# PlanGrid Task Report - Mar 2, 2026

**L05954\_Planters Station FSU (VA)**

TAB Punch List

**#48 [CNTL 499] [NEW] CRITICAL (MISC) – [TF-2 Thermostat not installed]**

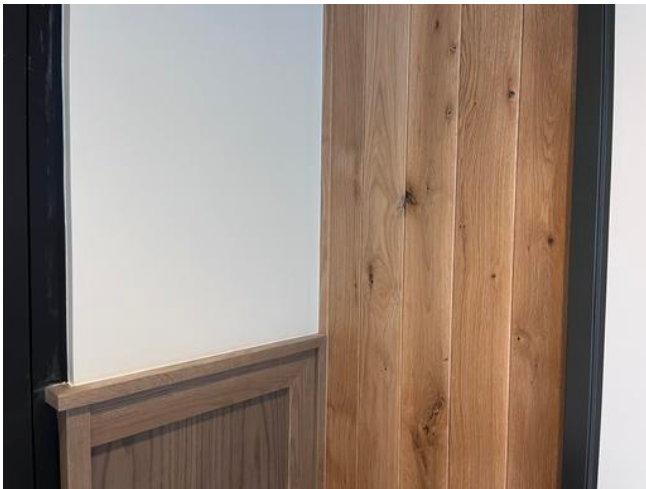
TF-2 seven-day programmable thermostat and rib relay are not installed. Fan is operational and was balanced to design cfm.
